# City of Santa Fe, New Mexico

# memo

**2026-012571-HDRB. 1295 Cerro Gordo Rd., Downtown & Eastside Historic District, contributing,** Harvey Monroe, agent for Anne Pfauth and Tomas Eric Sikes, owners, proposes to replace windows, construct 1,366 sq. ft. of additions to a height of 15'-0" and a 1,391 sq. ft. freestanding accessory structure to a height of 22'-11", where the maximum allowable height is 15'-3", and remove retaining walls. Exceptions are requested to sections 14-4.6(E)(4)(II) to remove historic material, 14-4.6(E)(2)(II)(c) to exceed 50% of the historic footprint, and 14-4.6(F)(2) to exceed the maximum allowable height.

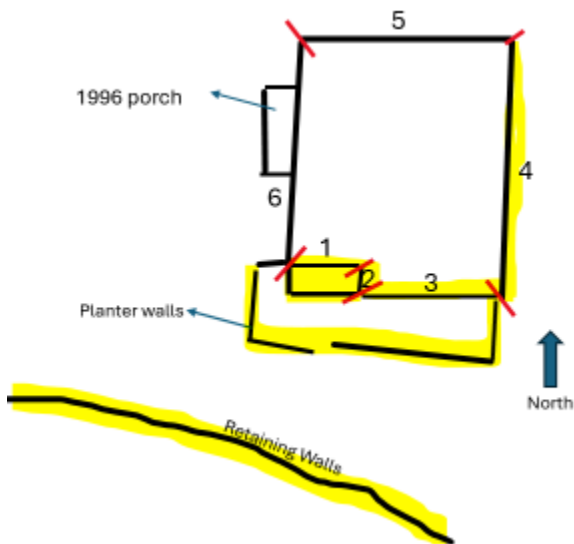
The origin of the stone retaining wall in front of the house is unclear. The low planters immediately in front of the house appear in earlier aerial photographs and lend period character to the property, helping to establish its historic setting; the lower rockwork is first clearly visible in 1978 aerial imagery. Both the low planters and the retaining walls are designated as contributing.
